October 9, 2007

Proposed Widening of IH-10 (from FM 359 to FM 3538)

Waller and Austin Counties, Texas

PRELIMINARY
CHANGE

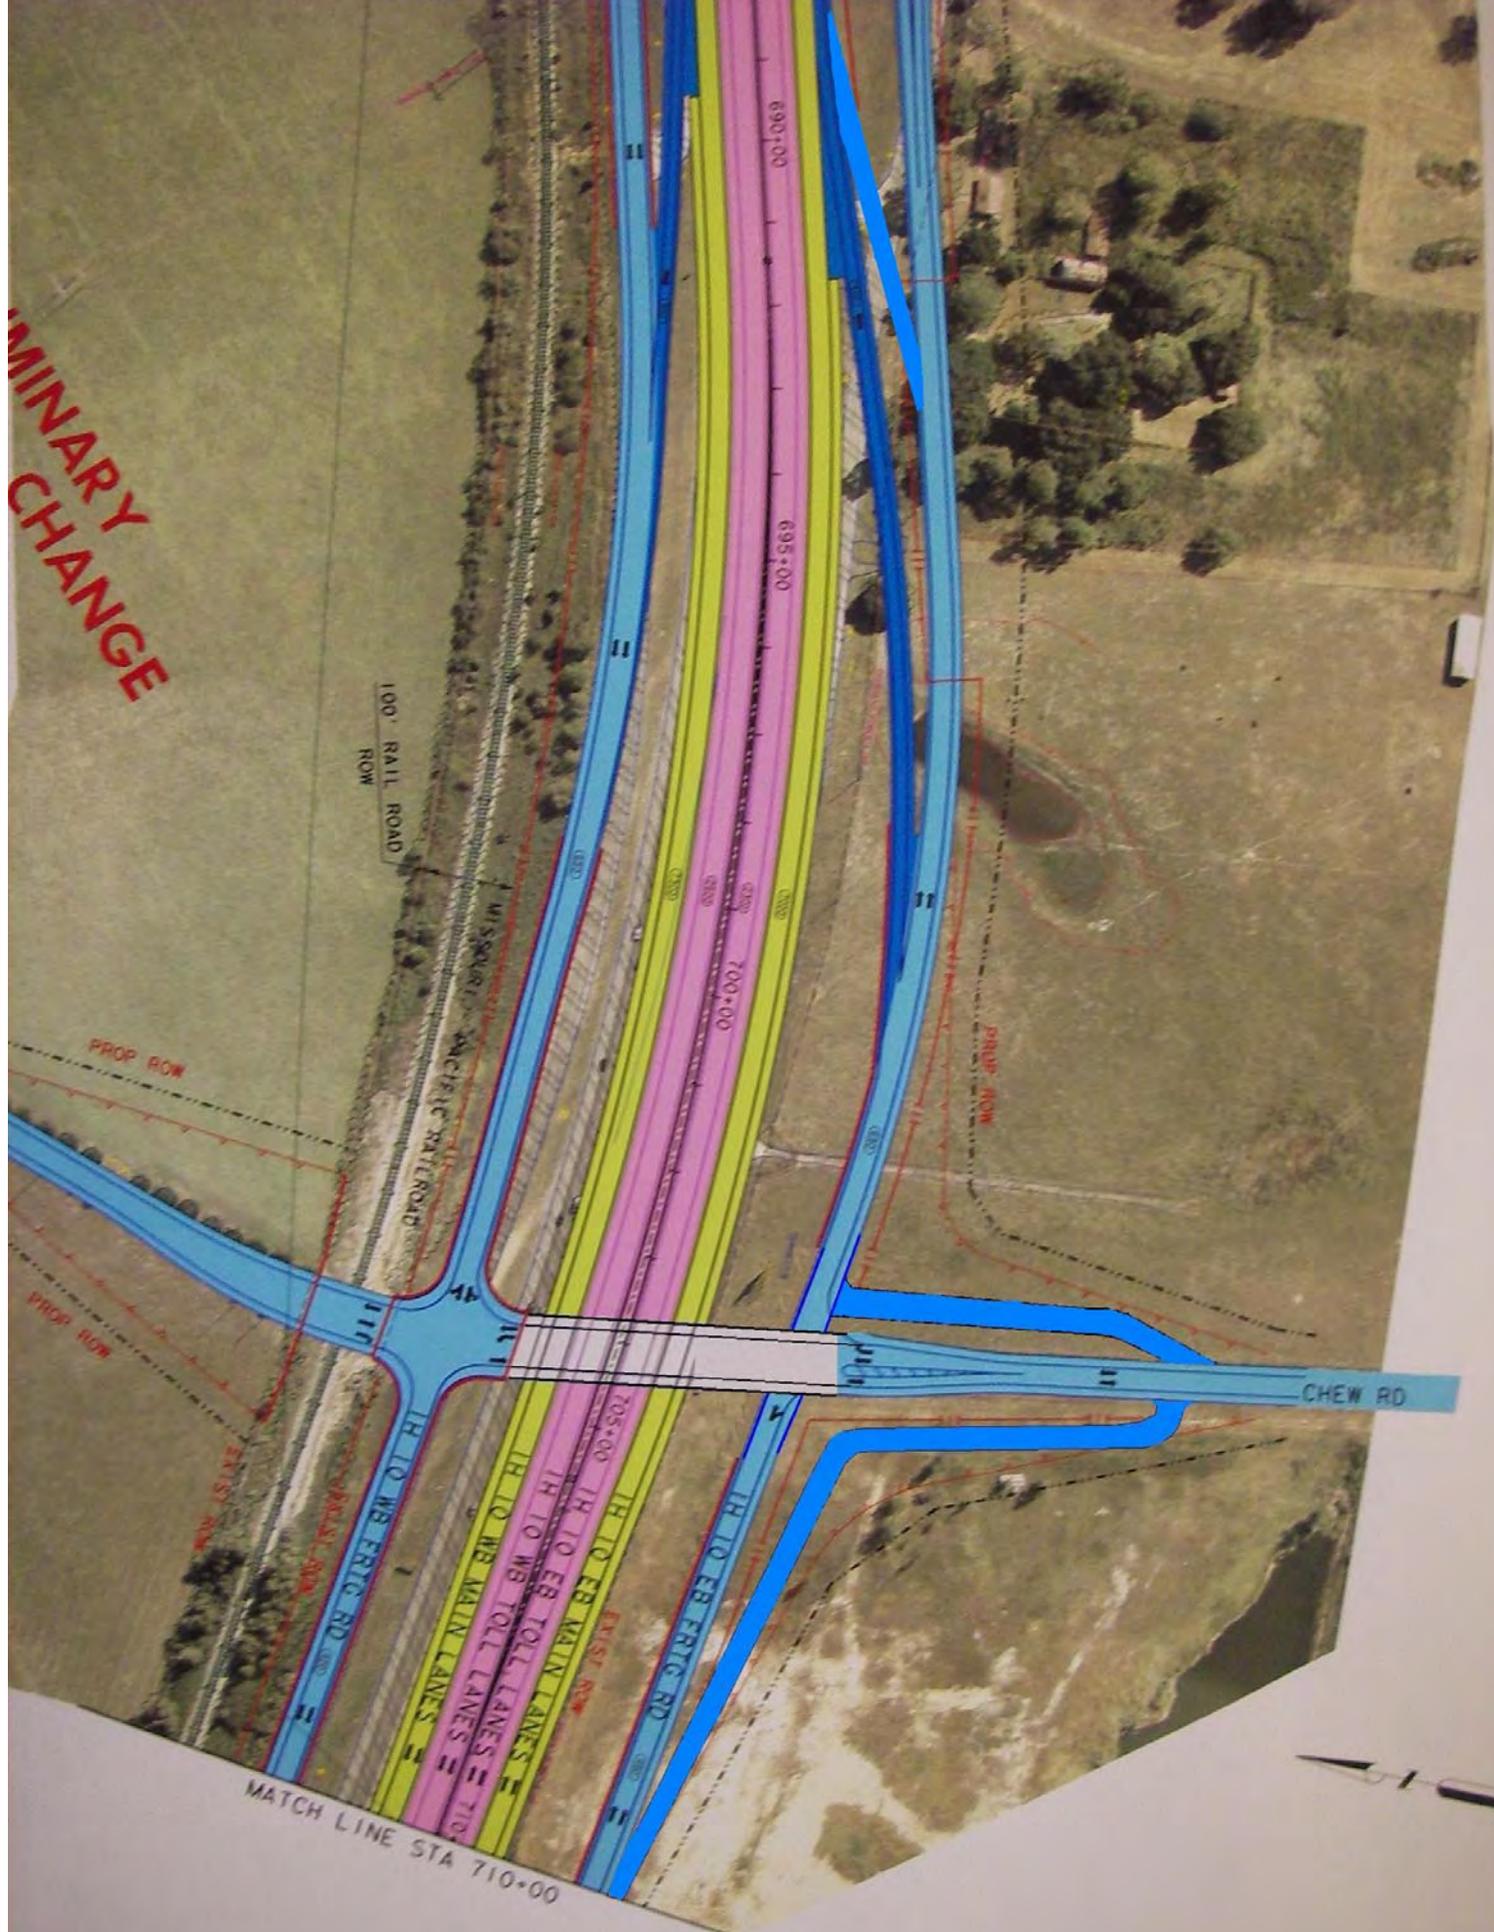
There is no reason to elevate the south frontage road at Chew Road Overpass at station 704+20. This design is not the only method to get the traffic off of the frontage road. This design will not provide the frontage to the property that already exists from station 695+00 to station 703+90 in the southeast quadrant of Chew Road Overpass.

YOUR CURRENT SCHMATIC DOES NOT DO ANYTHING FOR THE AJACENT LANDOWNERS OR BUSINESS BUT HURT THEM. THIS IS AN ALTERNATE SOLUTION THAT WOULD WORK AND WOULD NOT COST MORE THAN THE CURRENT DESIGN WITH RETAINING WALLS PARALLEL TO I 10.

NORTH OF IH 10 IS A DIFFERENT MATTER DUE TO THE RAILROAD TRACKS!

I am requesting the department to review this alternative as part of my response to the public hearing process in accordance with TxDOT procedures.
